RECEIPT DATE: 4/6/21 **ONSITE SEWAGE DISPOSAL SYSTEM** P 568842

APPROVAL DATE: 11/3/21 **PERMIT: REPAIR** A _____

RE: OSDS Plan
11486 Frederick Road
CLSI Job No.: 2020284

ONSITE SEWAGE DISPOSAL SYSTEM DESIGN PLAN
 11486 FREDERICK ROAD

PUMP CHAMBER NOTES & DETAILS

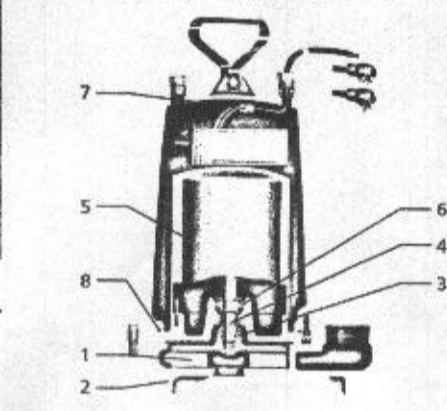
We offer the following responses to your comment letter dated January 22, 2021:

1. The coefficients have been revised.
2. The friction loss has been revised.
3. The volume in the pipe calculation has been shown.
4. The pump lid specifications have been revised.
5. Based on an email from the owner they have chose to have the disposal system for only 4 bedrooms.
6. The outlet pipe from the house was field verified.
7. The title has been revised.
8. The legend has been revised.

- DESIGN FLOW: 600 GPD (TOTAL 4 BEDROOMS)
- DESIGN HEAD:
 STATIC HEAD: 517.72 - 494.02 = 23.7'
 FRICTION HEAD:
 28' 1" OF 2" PVC = 28.1'
 1 - 45° BEND = 4'
 1 - 22.5° BEND = 2'
 1 - 22.5° VERTICAL BEND = 2'
 28.1' + 4' + 2' + 2' = 36.3'
 28.9' x 3.98 / 100 = 11.50'
 TOTAL HEAD: 23.7' + 11.50' = 35.20' @ 50 GPM

- DOSE VOLUME:
 USE MINIMUM DOSE = 100 GAL
 FORCE MAIN VOLUME =
 28.9' x 17.4" / 100 = 50.28 GAL
 ACTUAL DOSE VOLUME = 155 GAL
- PUMP CHAMBER CAPACITY:
 ONE DAY STORAGE CAPACITY = 600 GPD
 + DOSE = 155 GPD
 TOTAL STORAGE = 755 GPD
- PUMP ON TO PUMP OFF:
 D₁ = 1.53 X 23 1/8,305 = 4.31'
- HIGH WATER ALARM SWITCH TO PUMP CHAMBER:
 R₁ = 600 X 23 1/8,305 = 16.69'
